MCPB
09.18.03
Item # 11

MEMORANDUM

REVIEW TYPE: Site Plan Review
CASE #: ~~8-0338~~ **03038**
PROJECT NAME: Greencastle Towns
APPLYING FOR: Approval of 27 Townhouses
Article 59-D of the Montgomery County Zoning Ordinance

1. Grading and Retaining Walls and Stormwater Management

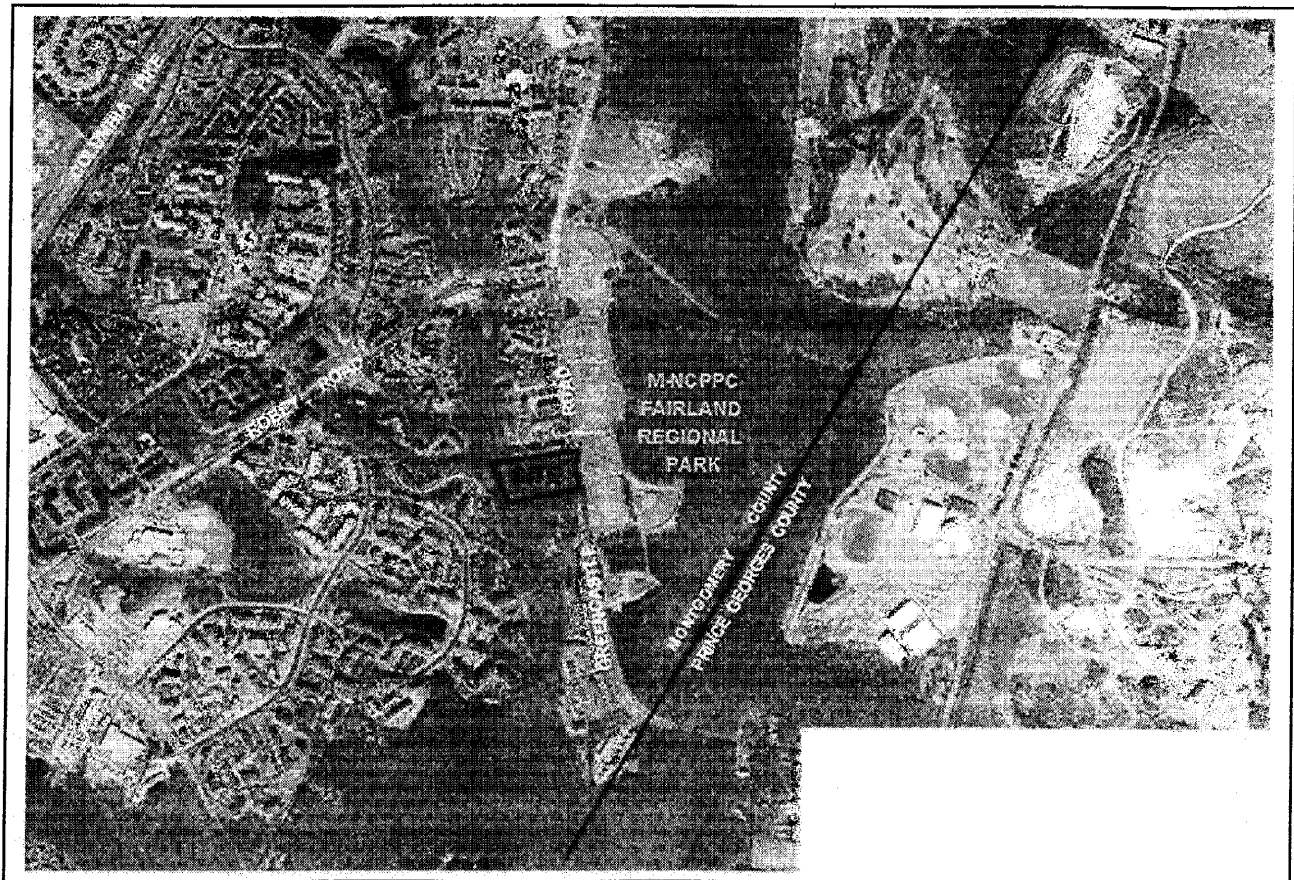
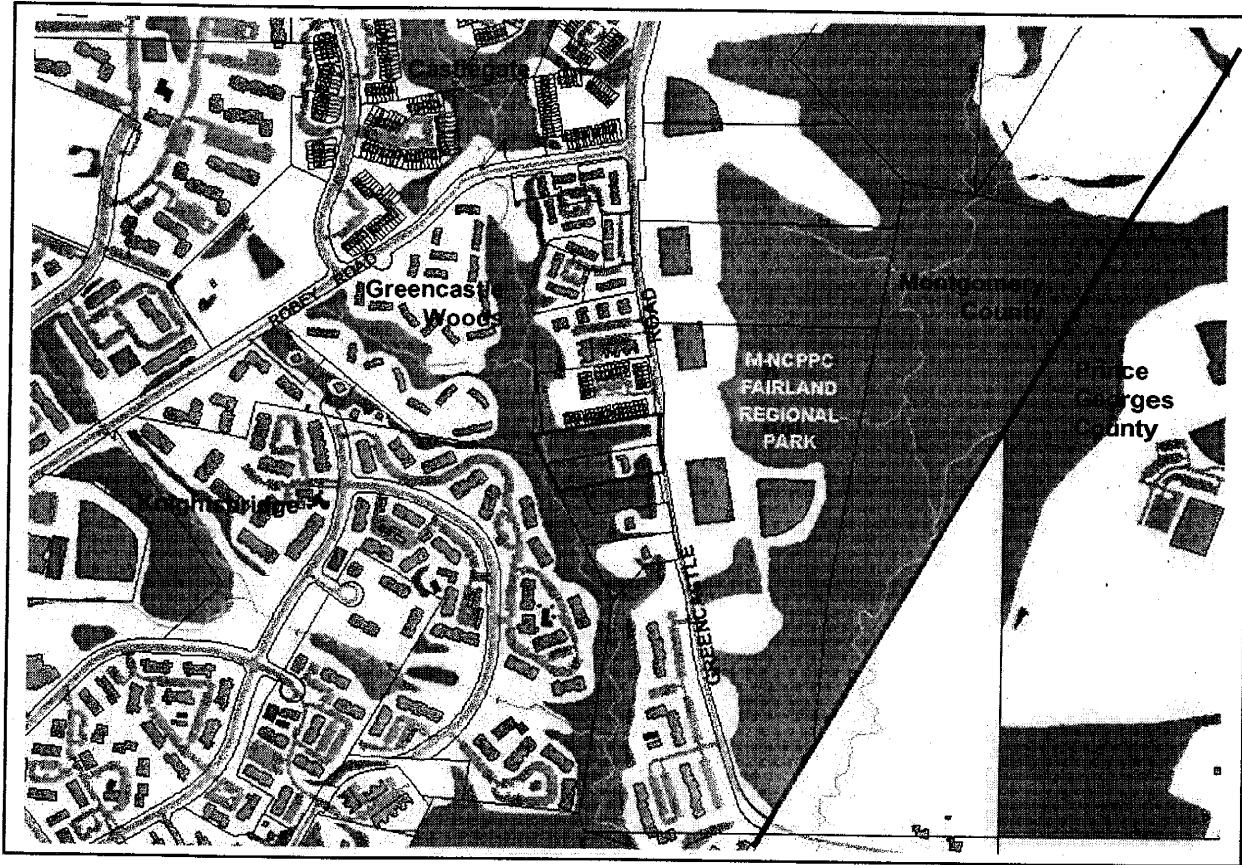
The shape and natural topography of this site along with the existing constraints of the Greencastle Road ROW on the east and the stream buffer on the west create what is essentially an “infill” site that demands careful consideration of building locations, parking and adequate companion open space. Providing adequate parking for residents and visitors on this “tight” site presents additional challenges. The applicant’s original proposal featured surface stormwater management (SWM) treatment at the site’s center along with recreational amenities at or within the stream buffer area. The locations of the rear line of townhouse lots, consequently, rested within 30 feet of selected points of the stream buffer, a condition requiring extensive construction of retaining walls.

Example: The original submission features approximately 487 linear feet of retaining walls, up to 10 feet in height, while the revised submission proposes about 220 feet of retaining walls with a maximum height of 4.3 feet.

Applicant Position: The applicant’s revised design addresses the SWM facility design by providing underground water quality and quantity control. The retaining walls have been reduced significantly in length and height. Formal recreational amenities have been relocated out of the stream buffer areas.

Staff Recommendation: Staff recommends the applicant’s revised plan, which solves the problems inherent to the original submission. The placement of the stormwater underground provides clear open space that may accommodate adequate recreation at the site’s center. The houses located along the stream buffer have been shifted forward, away from the steeper slopes of the stream buffer, which in turn, allows the reduction in the size and scale of the retaining walls, and their consequent impact on this environmental setting.
